Meeting Minutes
N -Springs Presentation to EPA / Ecology
January 24, 1995

N - Springs ERA

100-N Remedial Action Projects

**Presentation to Regulators
January 24, 1995**

90 Strontium Concentrations in Sediments Taken from the New Groundwater Monitoring Wells & Geotechnical Borings

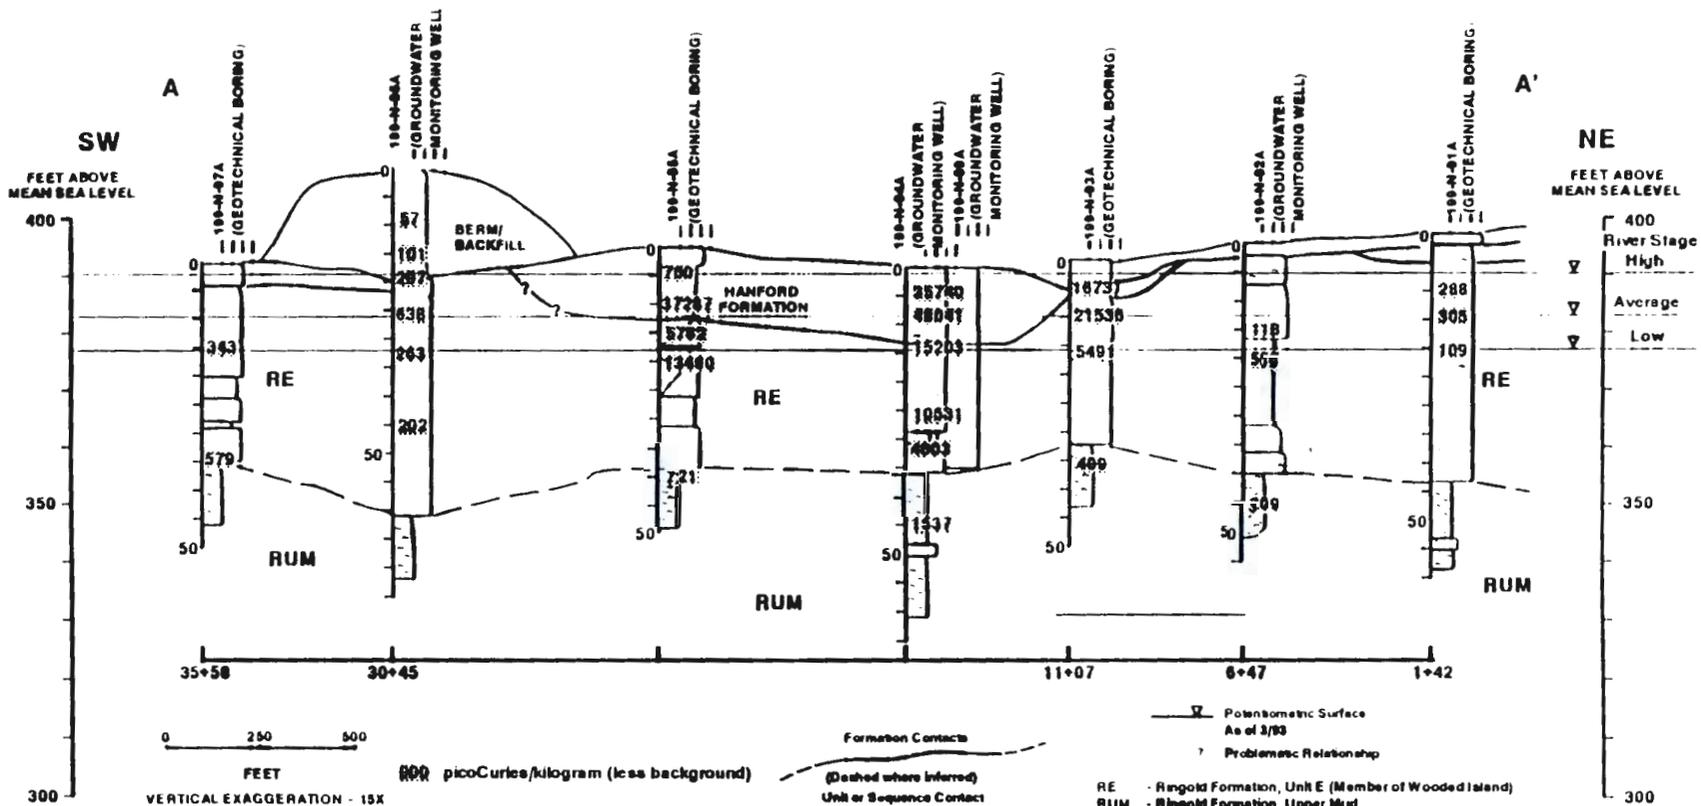
- * Strontium concentrations in sediments taken from the groundwater monitoring wells & geotechnical borings.
 - * Modeled soil contaminant distribution coefficient confirmed by laboratory results.

Model Predicted Equipotentials (ft) and Streamlines 2000 Ft Vertical Barrier

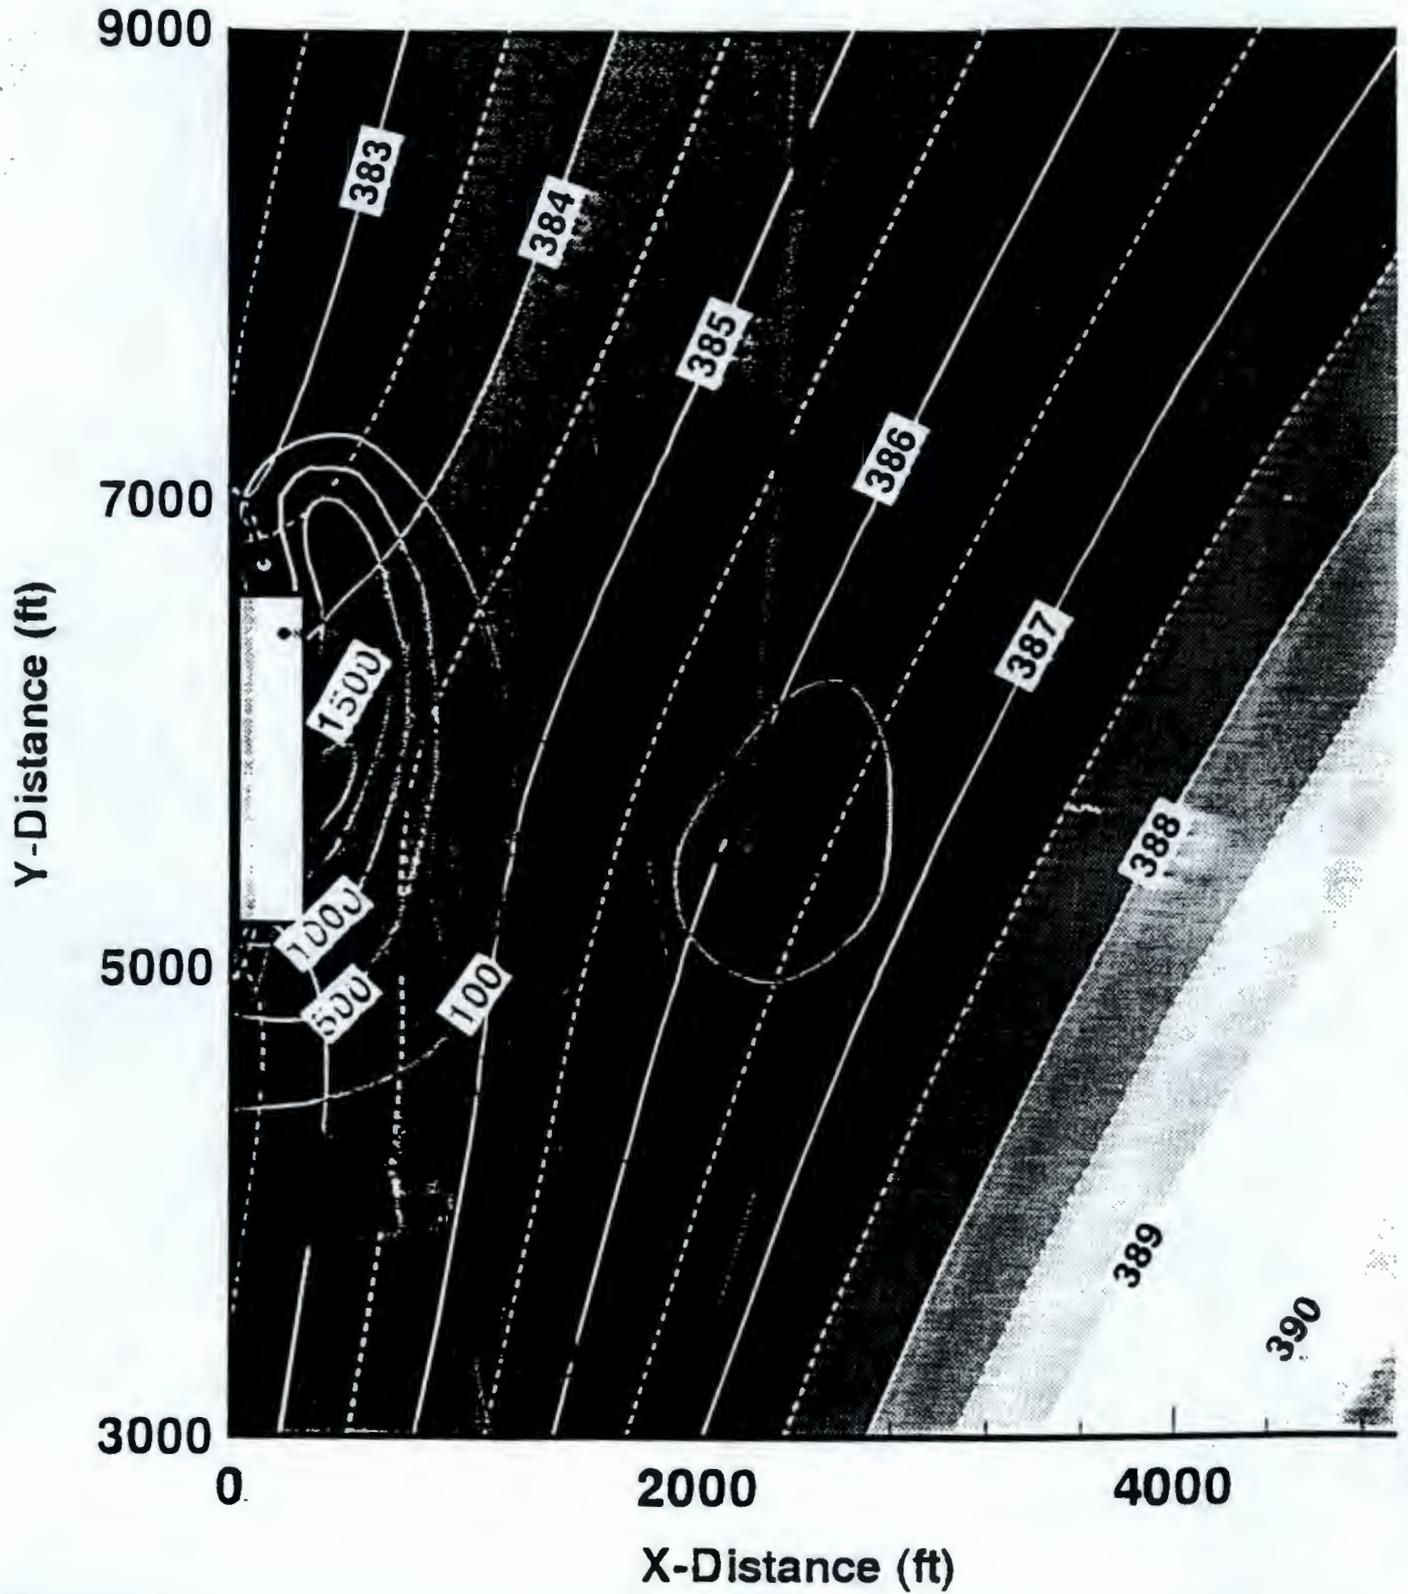
- * Address groundwater issues in the 100-NR-2 CMS/FFS
- Doug Sherwood voiced a concern over the number of wells used to gather data in the "erosional area" (identified as a white rectangle on the slide titled "Model Predicated Equipotentials (ft) and Streamlines - 2000 Ft Vertical Barrier). Sherwood's main concern was that there is only one (1) well in this area, and the data obtained was used as the basis for dropping the entire program.

- Sherwood questioned the assumption of using a steady state condition as a main driver, and that DOE/ERC did not look at the transient effects.
- Doug Sherwood indicated that by using a steady state analysis, the values are no longer conservative.
